Comment Response Letter

Project Name: Hendricks Commons

Project Log Number: DSRFY2023-0009

FLOOR PLAN -
LEVEL 2

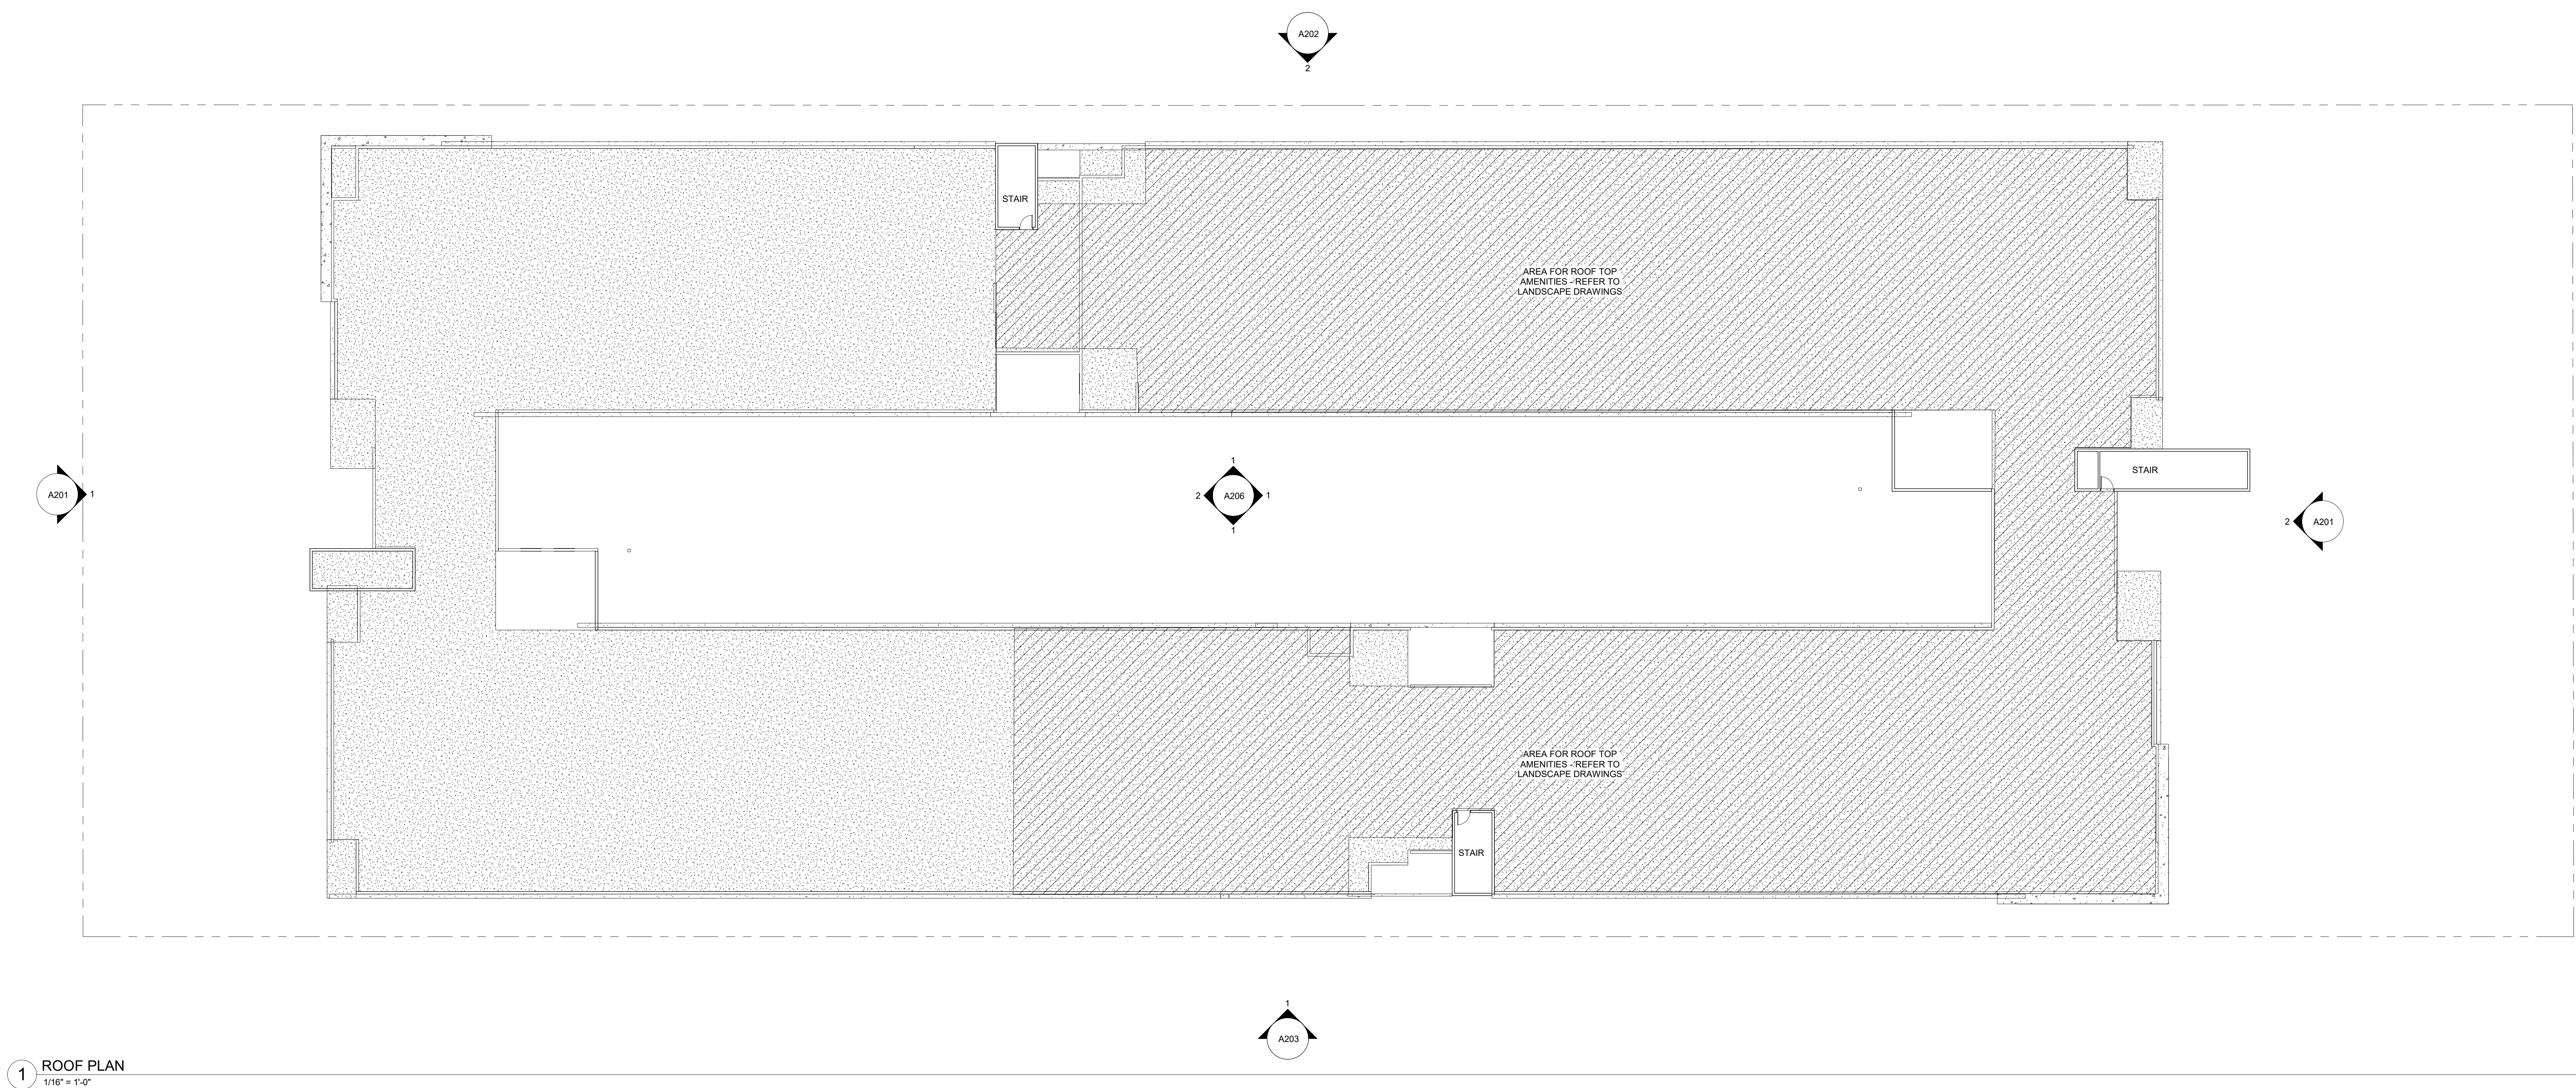
14. Consider covered bike parking in the garage.

Response: Covered bike parking was added to some of the storage rooms within the parking garage. See updated floor plan sheets A101 and A102.

4. 8-4D-3 Parking Design and Improvements
 - a. Please refer to revised drawings sheet A101 and A102 showing locations of bike parking and revised bike parking calculations. 247 spaces are

3 37th STREET

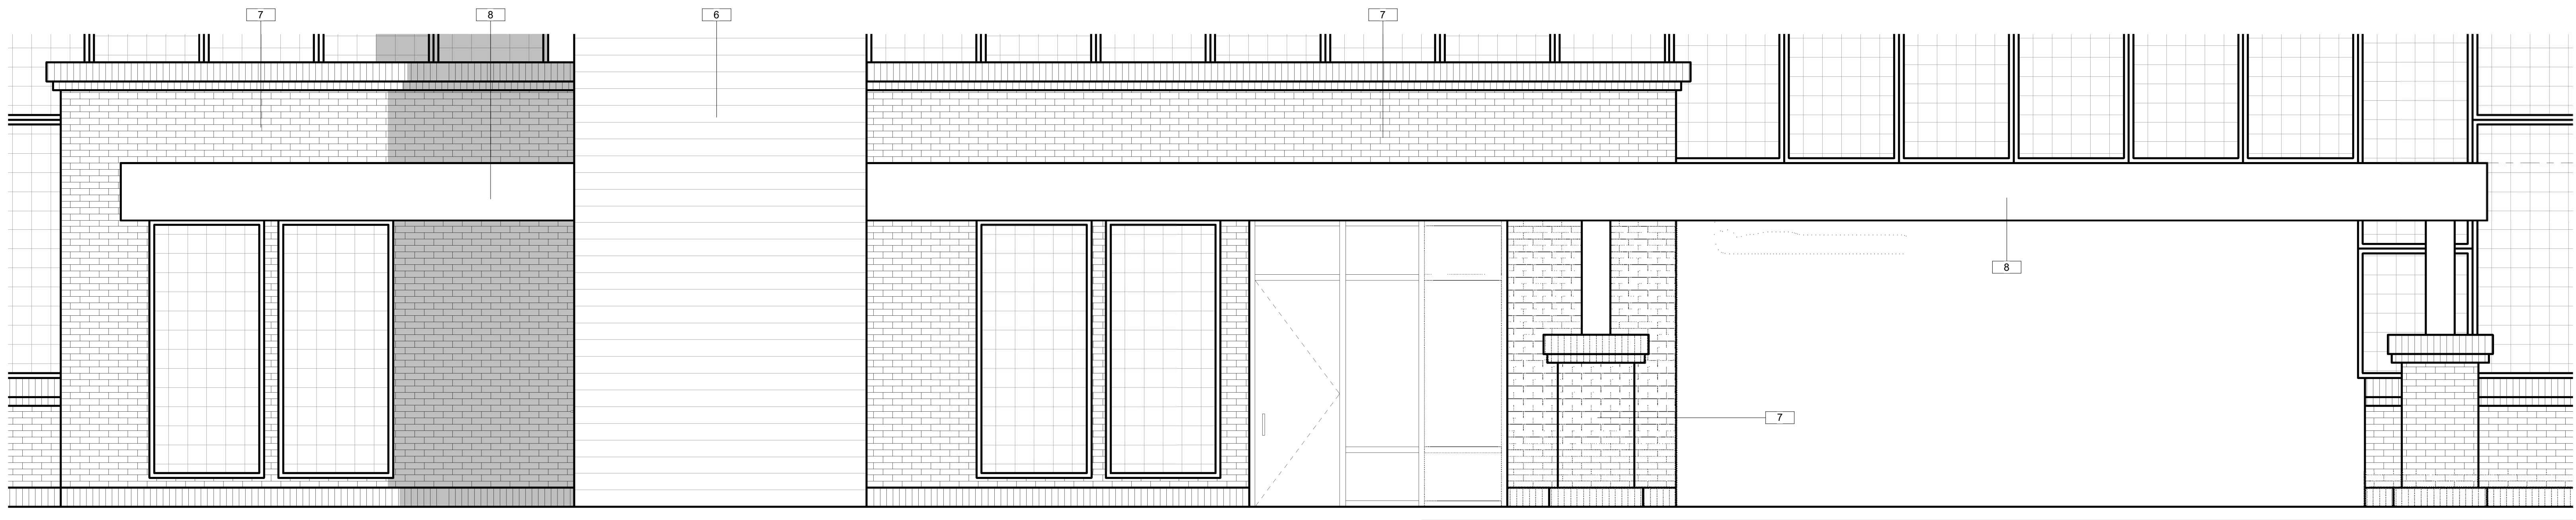
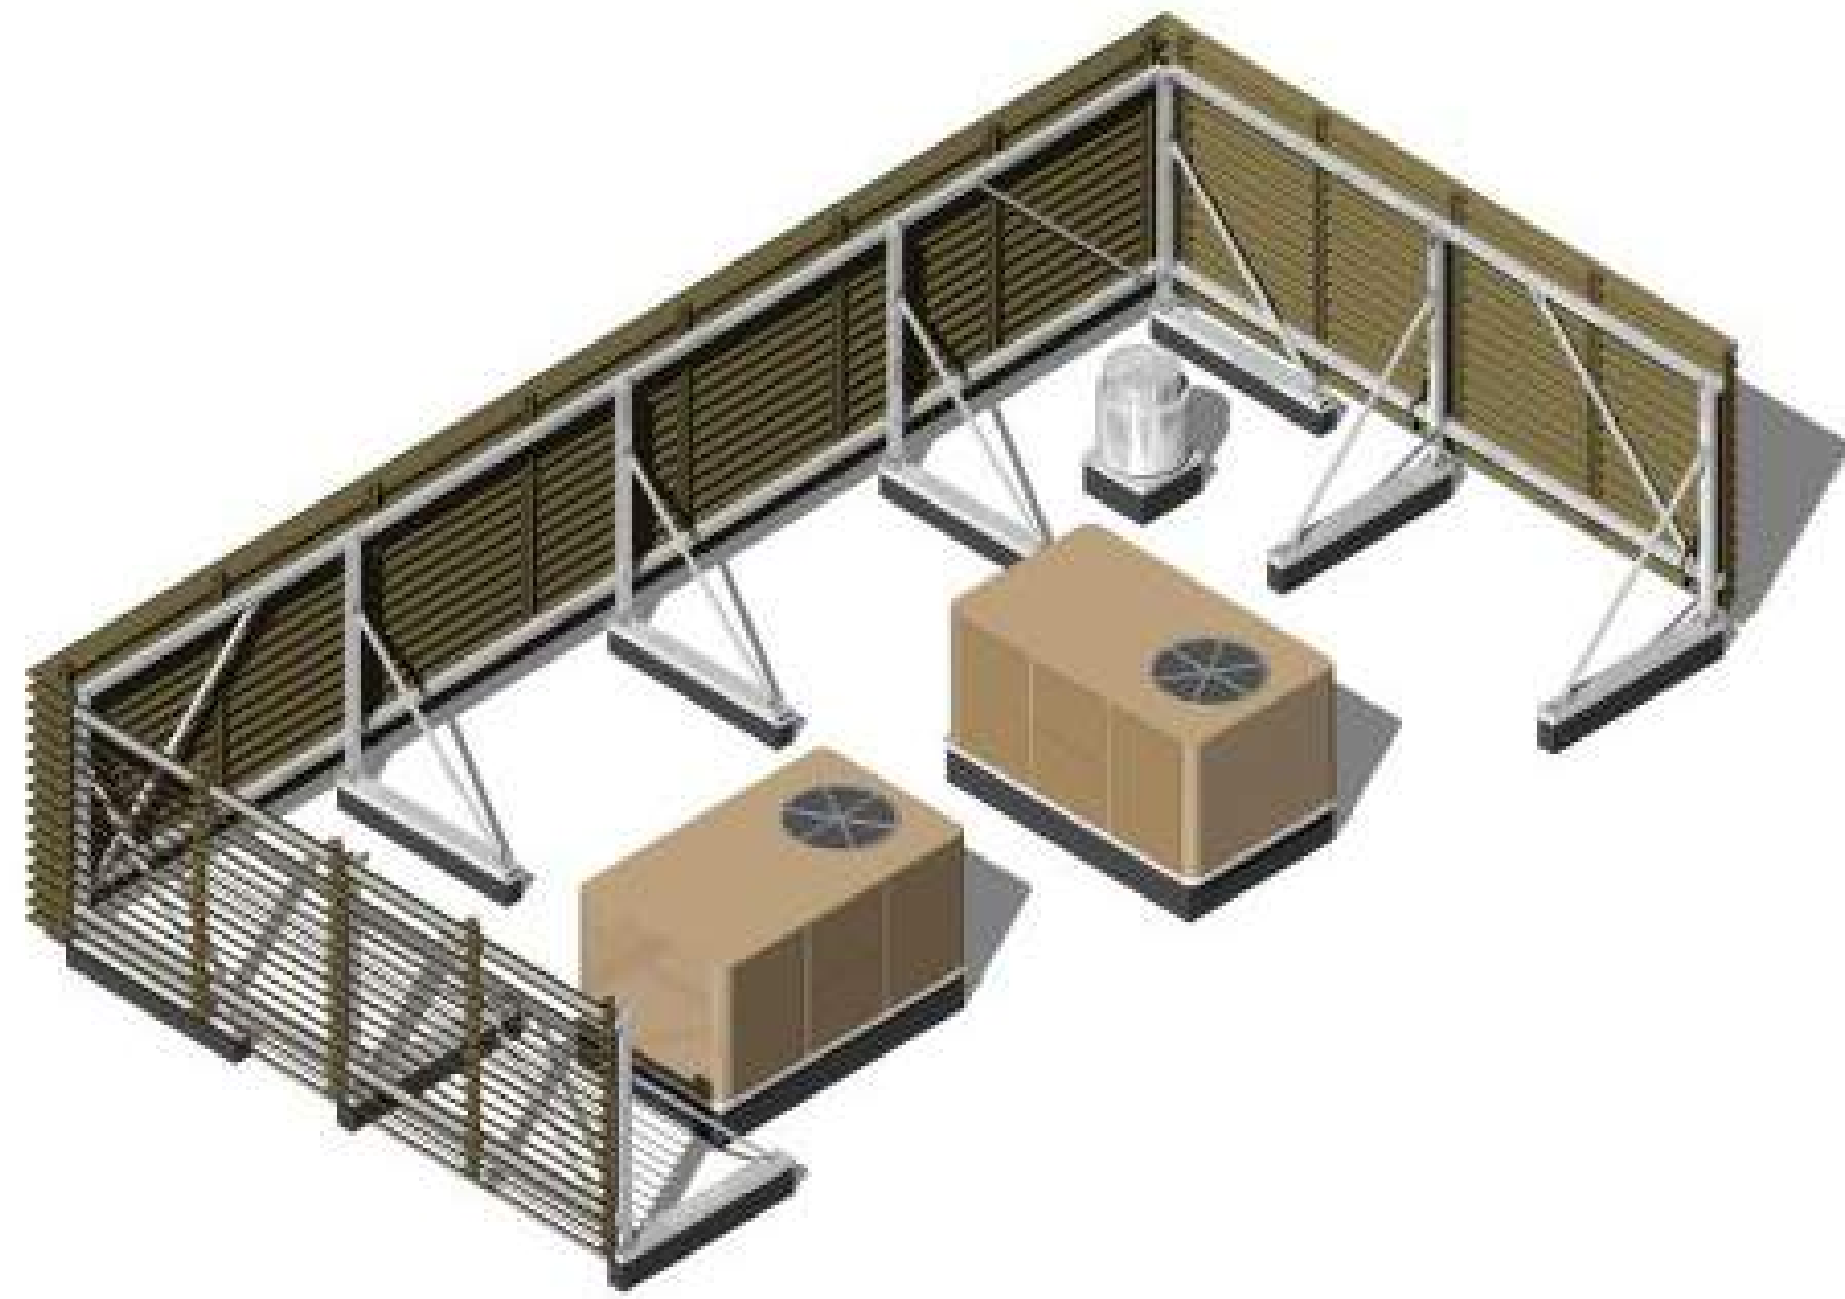
6. The 2-story parking garage portion of the project should comply with 8-4D-3A.9 Motor Vehicle Parking Structure Design.
 - a. Ground floor adjacent to the public right-of-way should be designed so the ground facades appear commercial in nature. Consider incorporating solid screen wall elements at the parking levels on the East and West street facing facades to lessen the visual impact of the parking garage.

Response: The parking levels fronting 37th and 38th streets were designed to appear commercial. Opaque parking screens are included to mimic a storefront system, brick columns and awnings highlight the garage entries. Brick walls, detailed with rowlock and soldier courses are provided at the pedestrian and amenity entries and storefront systems are provided with windows in these areas as well. See updated elevation exhibit Sheet A207.

3. 8-4B-4 Multi-family Residential Dwelling Units
 - a. The façade on 37th Street is different from the entrance on 38th Street. Please see added drawing A207 for a blown up view of the main entry and secondary entry. 37th street, which is designated as the main entrance to the building, features a two-story amenity space with traditional style brick and stucco work, large windows into the amenity spaces, and a rooftop patio with railings in portions to allow for a view to those open space areas from the ground level. There is also a plaza at the front of the entry to further highlight it as the main entry. The 38th street entrance is designated as the secondary entrance to the building. The 38th street entrance features similar brickwork to highlight the pedestrian entry, but is only a single story of brick, and does not project forward from the building.
